APPLICATION FOR HISTORIC AREA WORK PERMIT

LOCAL ADVISORY COMMITTEE REVIEW FORM

DESIGN PROBLEMS WITH NEW STRUCTURE PLANNED FOR 29 HICKORY

Re: Lot 11, Block 17, BF Gilbert Subdivision

Mountgomery Ave. Side

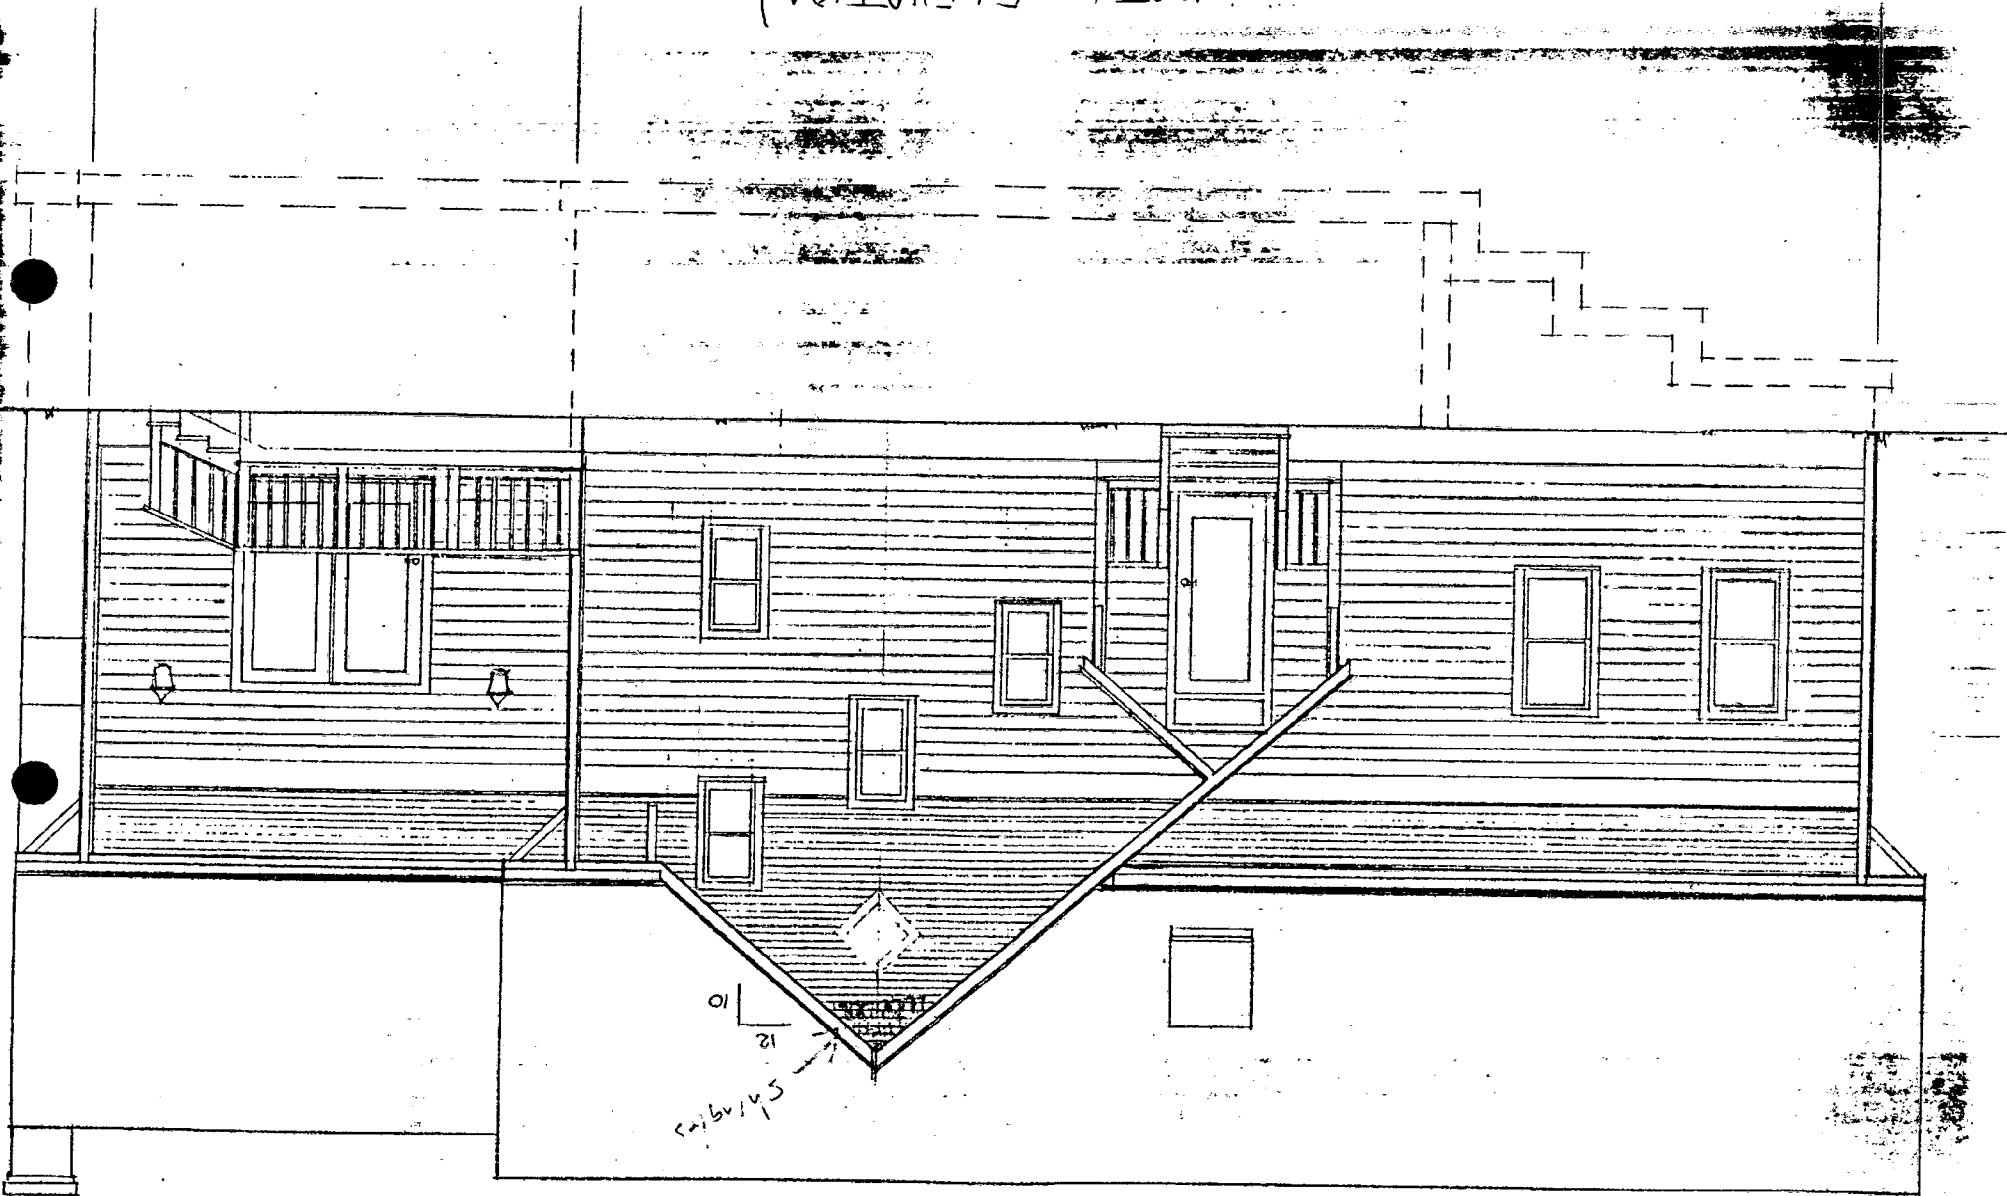
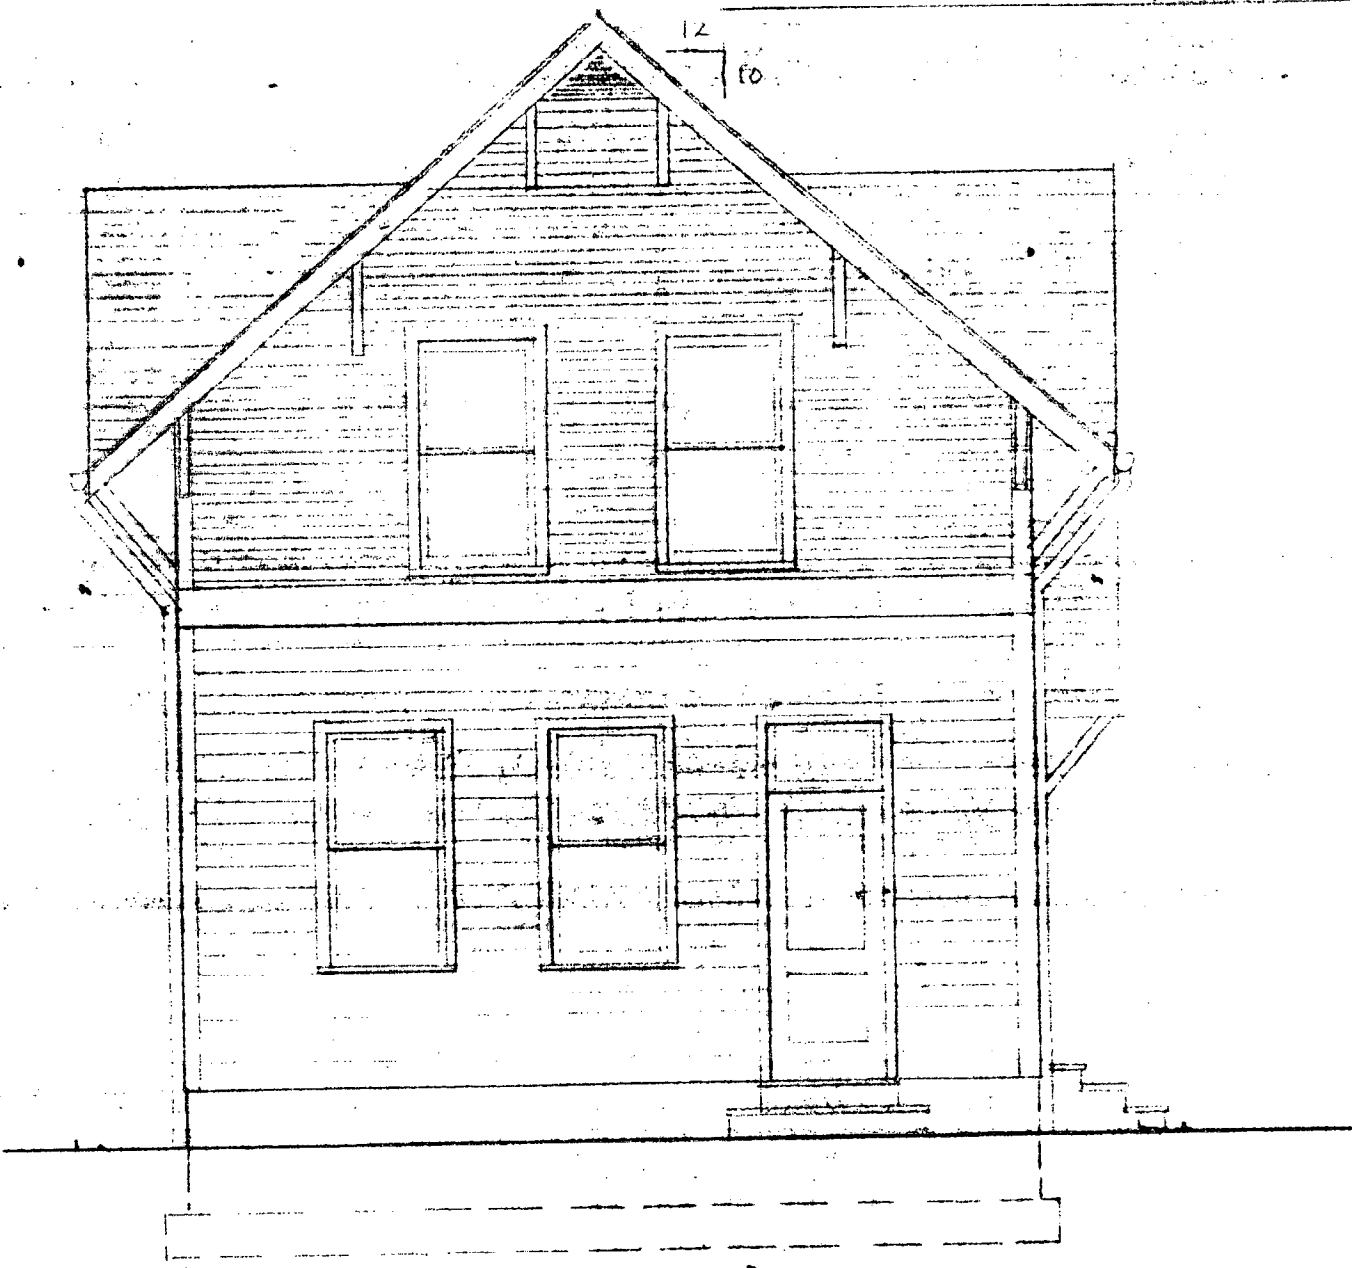
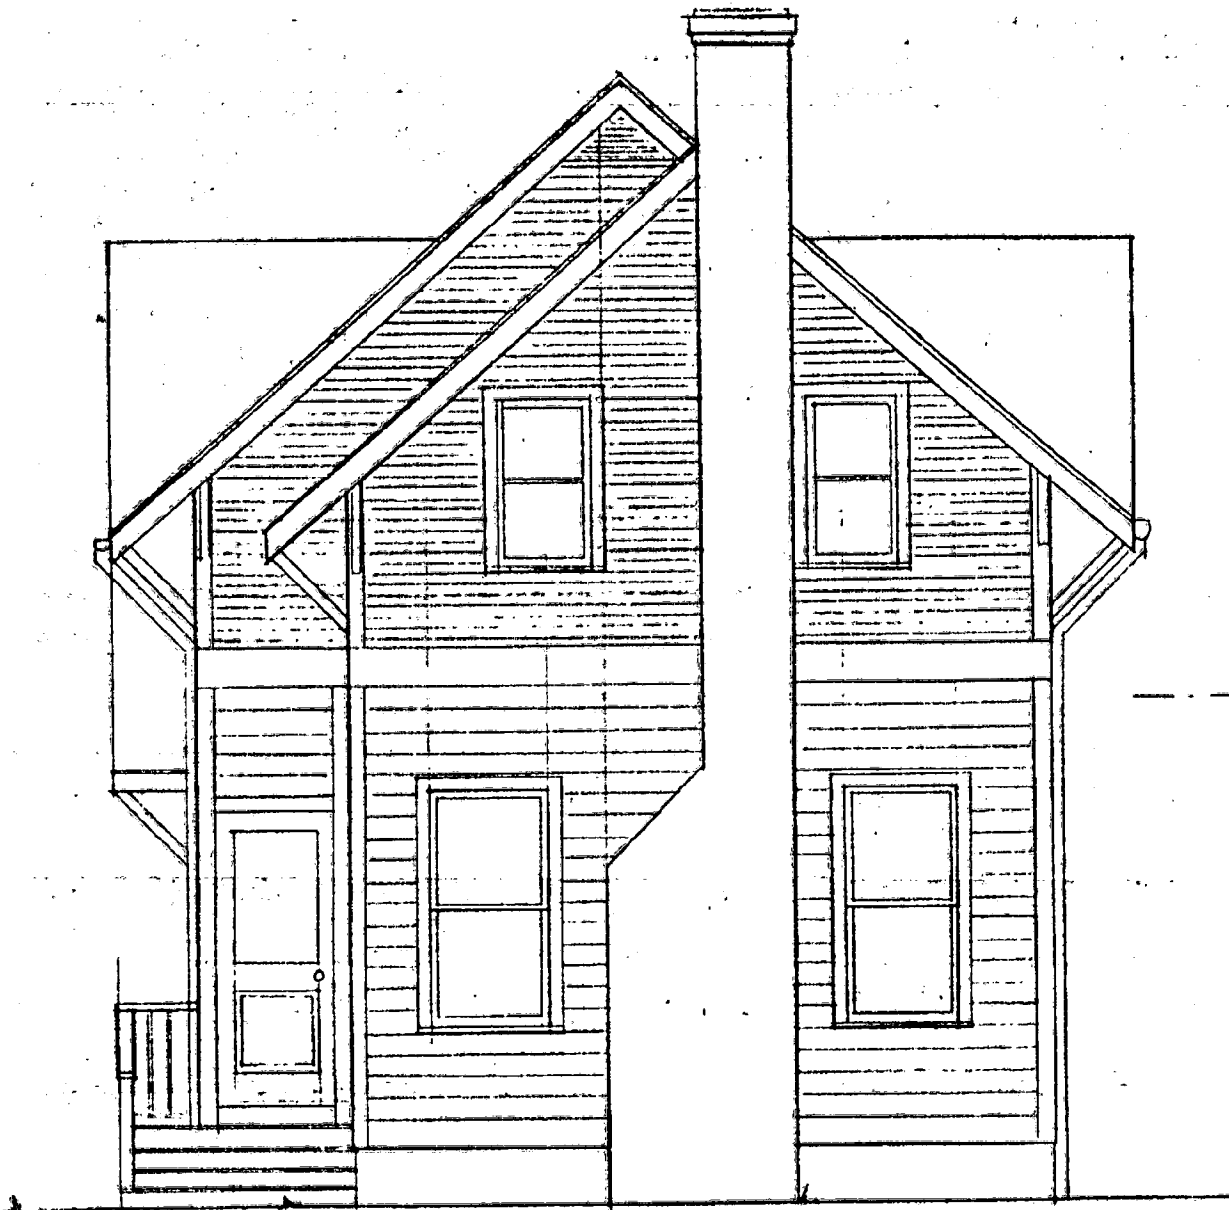
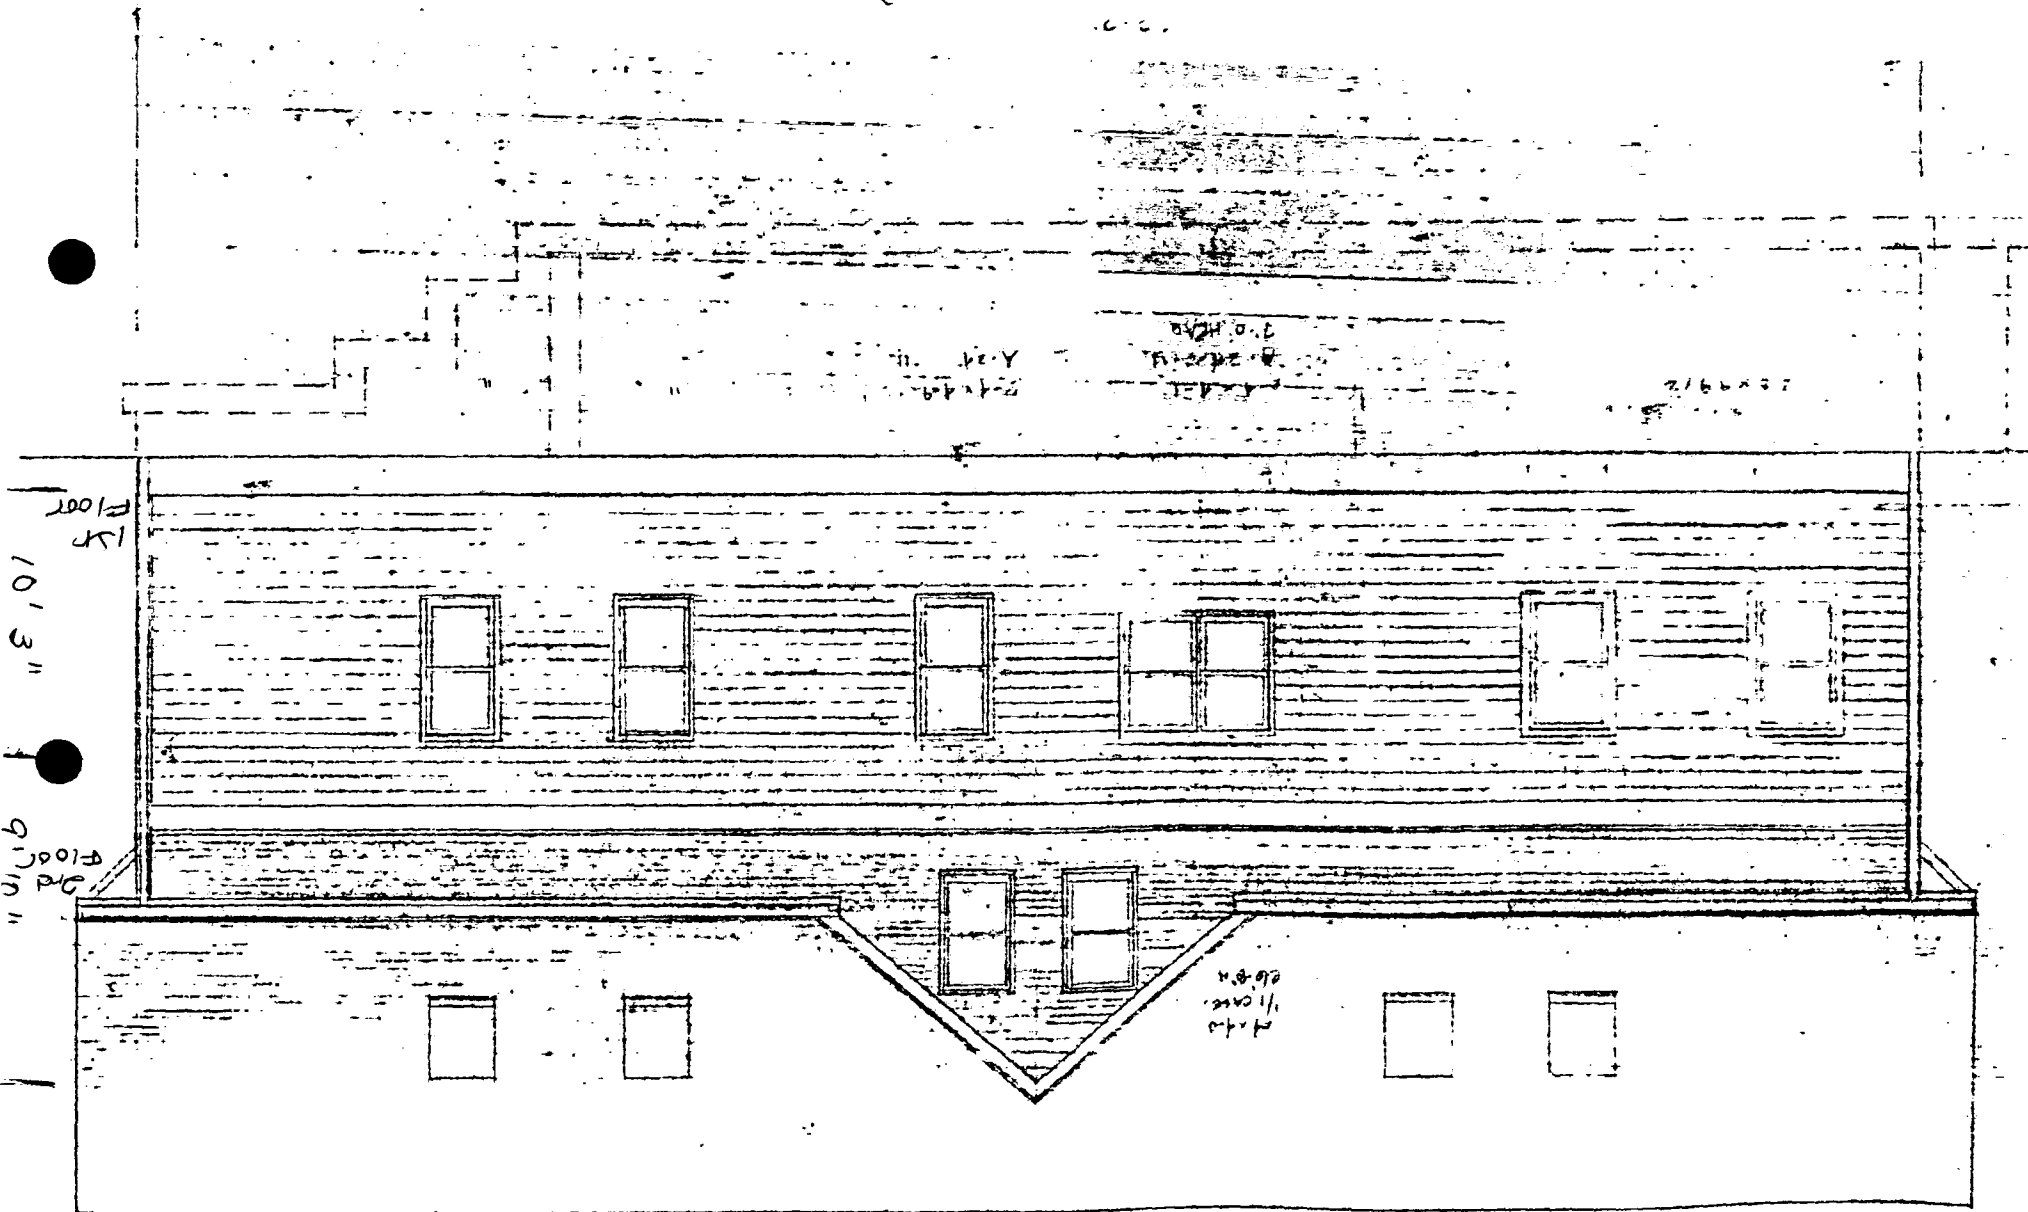
1. Long, tall wall, 60 feet long that faces Montgomery will have overpowering visual impact. It is longer than the wall of neighboring structures that face the street...and appears completely unrelieved. We think it may give the impression of being a multifamily structure.

2. It is different in a basic way from the surrounding structures in that it consists of one rectangular volume. Neighboring houses contain a variety of volumes such as enclosed porches, front porches, bays and additions.

3. The fact that there are no functional windows on the second floor on the side facing Montgomery reinforces the sense of massiveness. We do not believe that the small, oddly oriented and asymmetrically spaced windows will relieve this effect.

4. Since the proposed structure is 6 feet taller than the existing structure, only 13 feet away and flush with the front and longer in the back, it will visually dominate the existing structure and block out the sunlight and view from the northwest side.

5. We think the overall shape is not appropriate to a corner lot, but looks more as if it belonged on a narrow urban lot surrounded closely by houses of similar design on both sides. An interior placement would disguise the unusual scale of the proposed design. On the corner, it is obvious.

6. The negative visual impact is compounded by the fact that the house is on the corner where it is seen both by people on Montgomery and by those coming down the hill on Hickory.

1. More effort to break up long, horizontal ~~facade~~ facade on Montgomery Avenue
2. Add porches or other details to relate

IV. Additional comments the house to its neighbors & relieve the facade
